**STAFF REPORT
FOR THE PLANNING COMMISSION**

FILE NUMBER: CUP-13-03/DR-13-07/VAR-13-12/VAR-13-13/MISC-13-07/VAR-14-02

REQUEST: Conditional Use Permit, Class II Design Review, Permit to Enlarge/Alter a Non-Conforming Structure for building modifications and additions and site modifications at Youth Music Project at 2015 8th Avenue, with Class II Variances for front gables and for stained glass windows and a Class I Variance for sign type face.

RECOMMENDATION: **Approval of all requests except the Class I Variance for sign font; subject to Conditions of Approval**

1 SITE PLAN

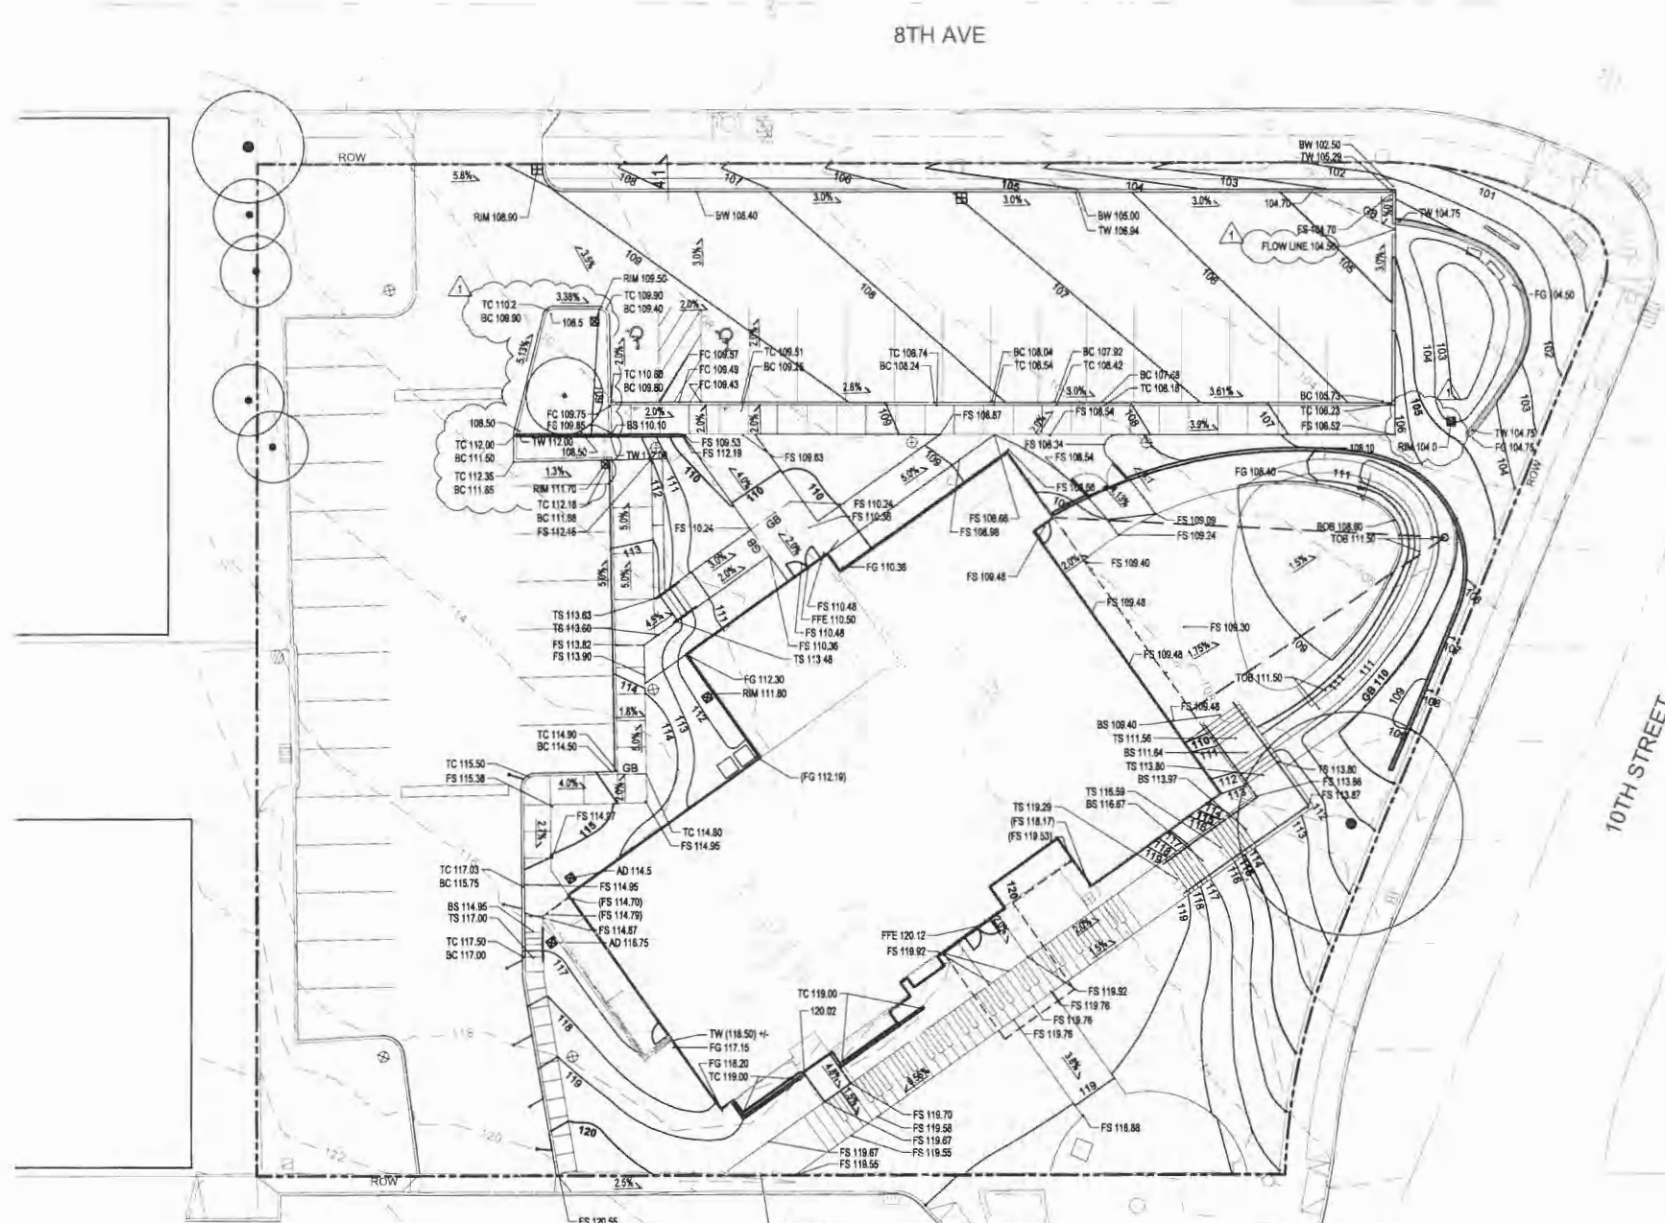
1. Site Plan and Elevations. With the exception of modifications required by these conditions, the applicant shall adhere to the Site Plan, Sheet L-1.2, dated November 12, 2013, on Page 190 of Exhibit PC-3, and the Exterior Elevations sheets A3.0 and A3.1, on Page 201-202 of Exhibit PC-3, all dated November 12, 2013.
2. Disabled Parking. The van-accessible disabled parking space shall be provided with a sign indicating it is van-accessible.
3. Litter Receptacles. The applicant shall install two litter receptacles on site, outside of walkways and not within any public right of way.
4. Signage Font Variance. The signage font shall be one of the allowable fonts pursuant to CDC 52.210(K)(2).

Staff Response 32: The parking lot currently has no interior landscaping, so it is non-conforming. To be conforming 10% or more of the lot shall be landscaped, and there should be a landscaped island for every 12 spaces. There is only one island proposed for 36 spaces, and this is less than 10% of the interior of the parking lot. (It is more than five feet wide, so staff determines that [b] is met.) However even the addition of this small island makes the site more conforming. See Staff Response 71 for how this meets the 66.080(B)(2) criteria of remaining non-conforming while not increasing the non-conformity. The applicant has agreed to an appropriate soil and irrigation system, so staff determines that (c) is met.

Staff Response 33: Currently there is no strip between the parking and the right of way along 10th Street or 8th Avenue, so the site is non-conforming. The proposal would create an over 20-foot wide landscaped buffer area between 10th Street and the parking lot, which more than fulfills the need for a “strip”. As for the area between 8th Avenue and the parking lot, this cannot be a very wide strip and still leave room for parking. This is due to the depth of the site in relation to the size of the building. There will be a strip here, unlike the existing situation, but it will be two feet wide and not ten feet. Therefore the area will continue to be non-conforming but less so. See Staff Response 71 for how this meets the 66.080(B)(2) criteria of remaining non-conforming while not increasing the non-conformity. This strip will be landscaped in a way that fulfills (2) and (3) above; there will also be street trees planted between the sidewalk and 8th Avenue fulfilling the need for street trees (and fulfilling the spacing requirements as well) in (1). Staff determines the criteria are met except in the ways that the property remains non-conforming, but the changes are acceptable as they makes the property less non-conforming.

Staff Response 31: Two accessible spaces are provided. One is van-accessible. Recommended Condition of Approval 2 requires this space to be signed as van-accessible. Staff determines the criteria are met upon the inclusion of Condition of Approval 2.

Sheet Name
EXTERIOR ELEVATIONS

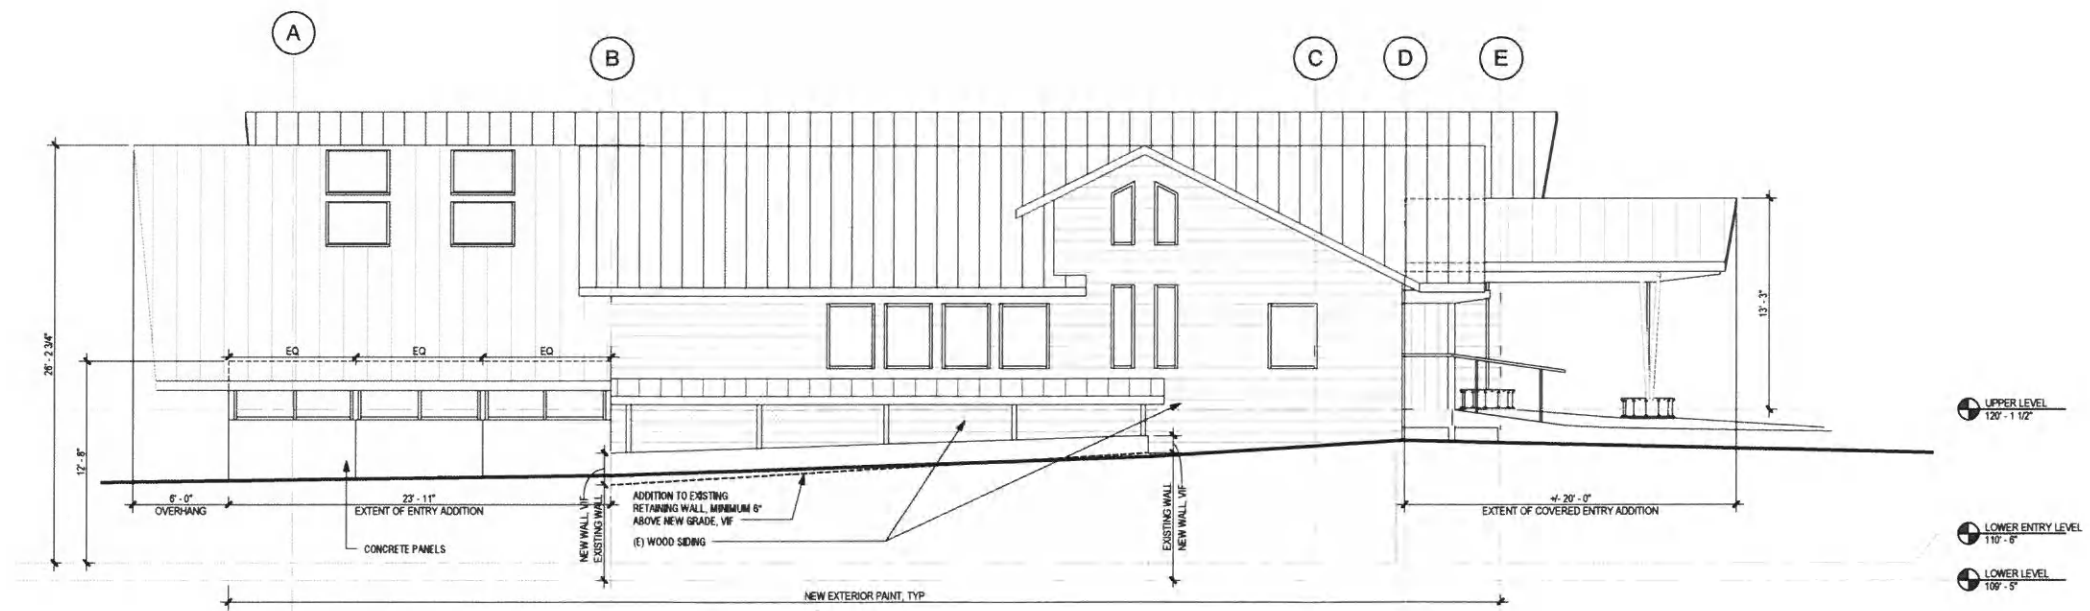
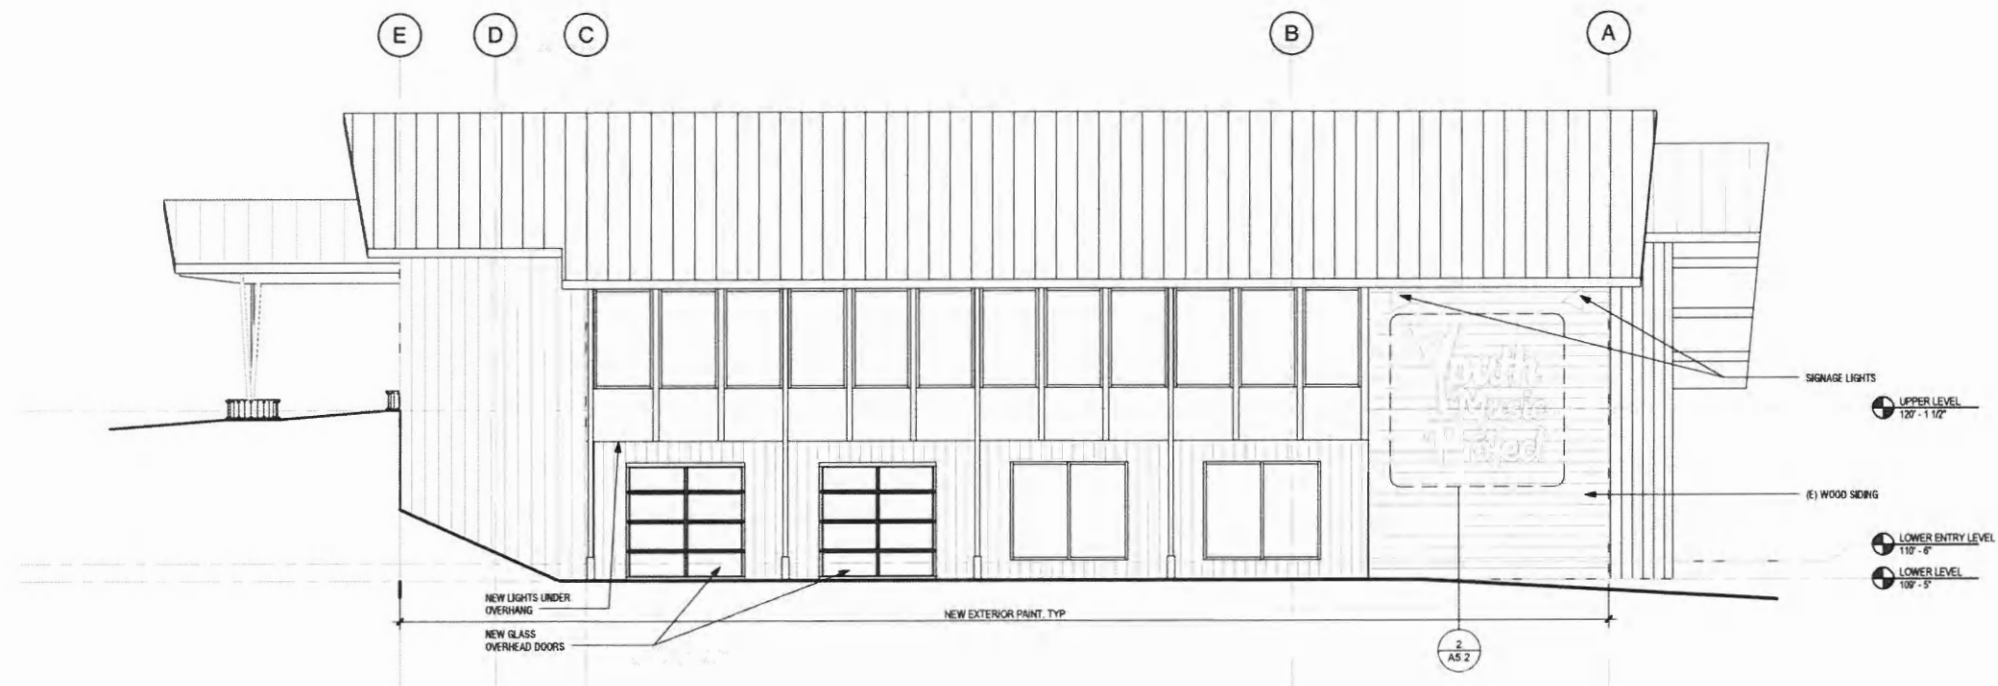
Staff Response 12. The building is non-conforming in that there are already two gables and a pitched roof exposed to Willamette Falls Drive. The proposal would make the building more non-conforming to this as it would add a gable facing the street with the front entryway. Therefore this is covered in both the non-conforming section below (see Staff Response 71) and in staff responses 72-77 which address the Class II Variance relating to the proposed new gable.

Staff Response 15: This is a former church building which still reflects the mid-century church style in which it was built. In the tall front sets of windows which clearly reflect this style of architecture, the applicant proposes stained glass. While this is appropriate for the style of windows and for the heritage of the building, it requires a variance from the wording of this subsection. See staff responses 72-77 below regarding the requested variance.

SOUTHEAST BUILDING SIGNAGE ①
1" = 1'-0"

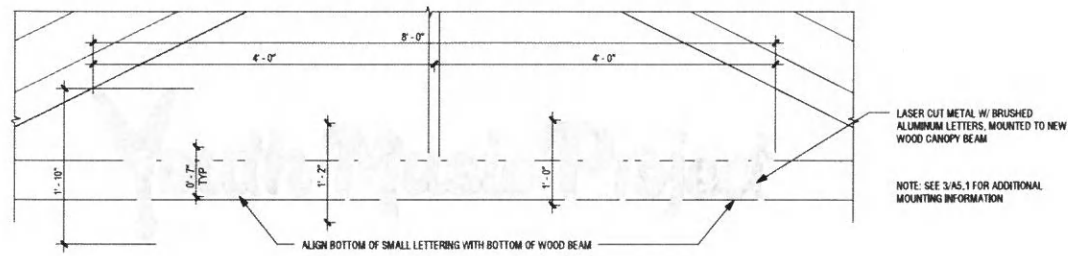
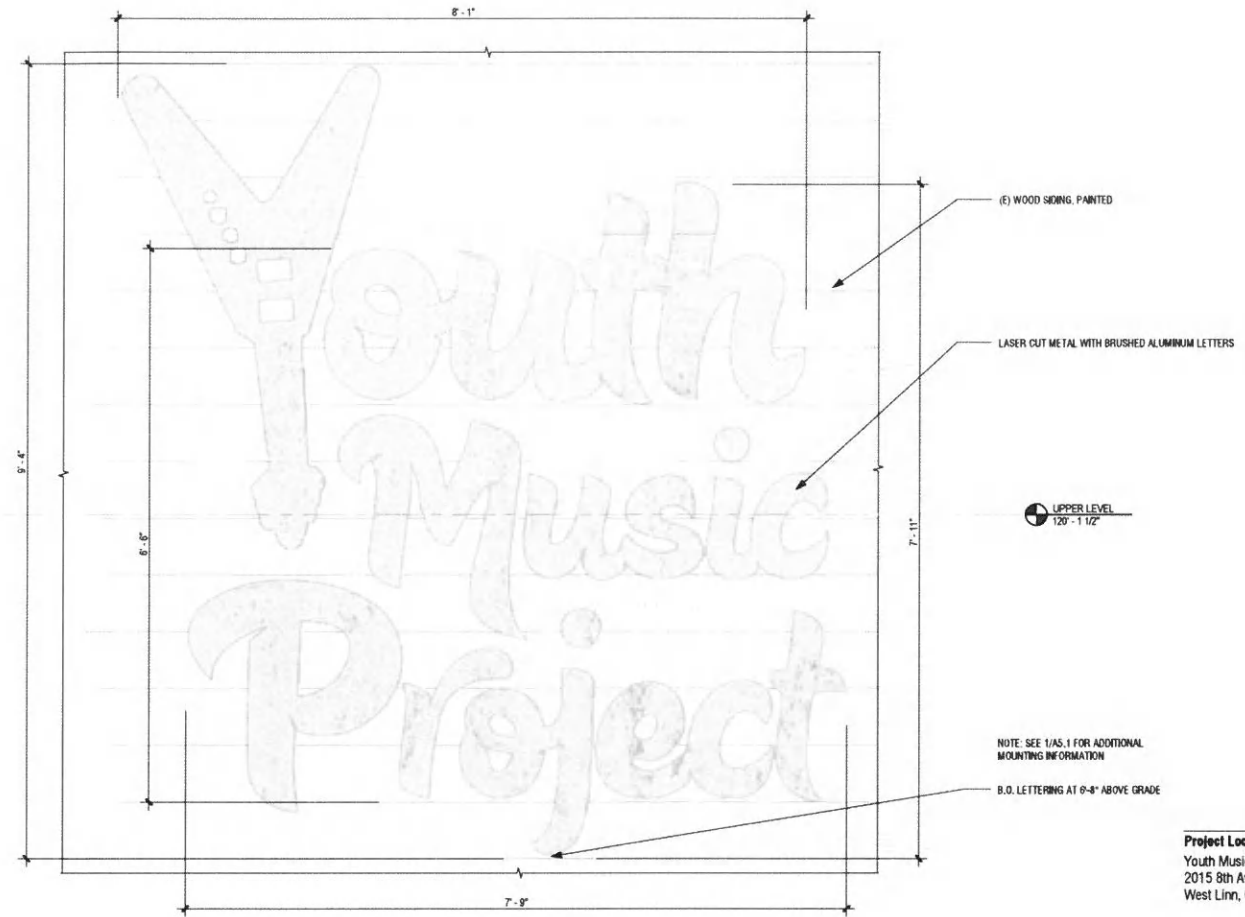
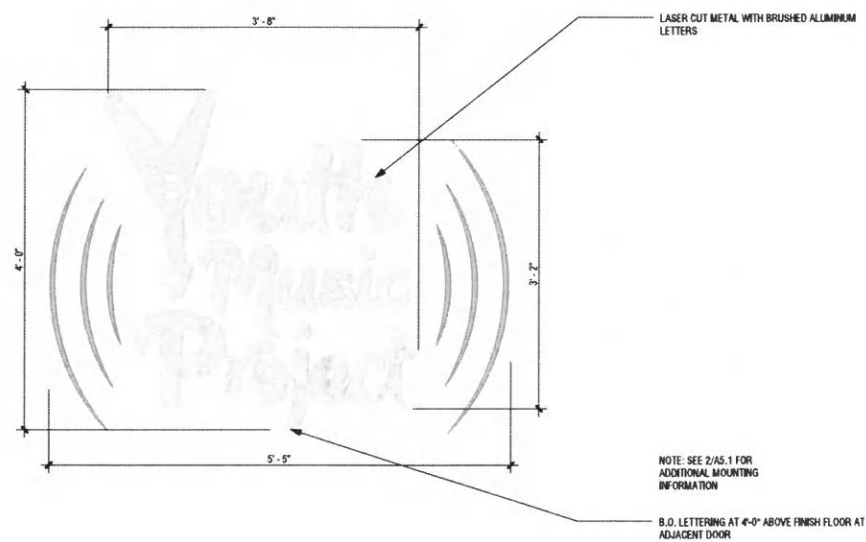
Staff Response 38: The applicant has applied for a Class I Variance to not use historic font. See staff responses 39-41 and 72-77.

Staff Response 39: The architecture is unique within the overlay district, but not in a way that prevents having a historic font. Having a historic font would still allow the applicant to identify their business. Staff determines the criterion is not met.

Staff Response 41: This is not a sign size or placement variance. As a font variance it is hard to say whether it is the minimum necessary; the appropriateness of this particular variance relies more on criterion (C)(1) above which staff finds the proposal does not meet.
